GRAND TERRACE

ANNEXATION AND SITE DESIGN REVIEW
FOR THE PROPERTY AT 1511 HWY. 99 N

RE: PA-T3-2019-00001, 1511 Highway 99 North

ANDERSON AUTOBODY FRONTAGE

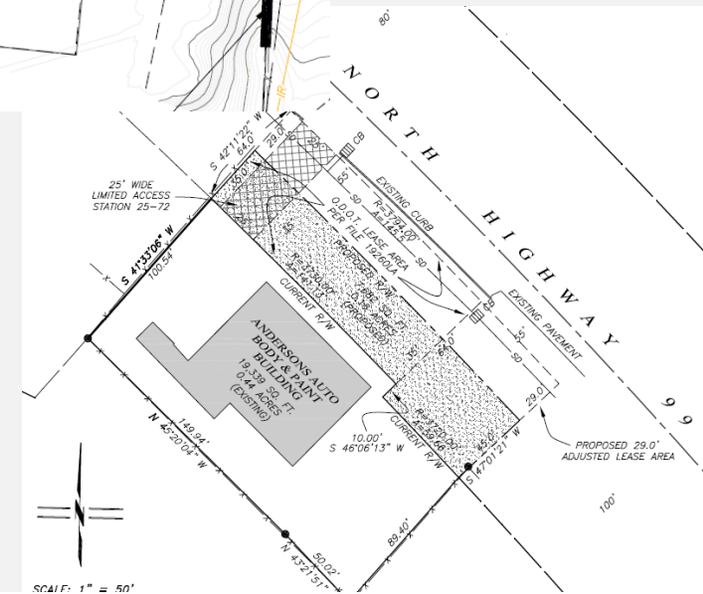
Concern that the improvements were encroaching onto Anderson Autobody property were raised.

All sidewalk improvements are outside of the private property area and are approximately six-inches outside of the easement that extends from Anderson Autobody into the ODOT ROW.
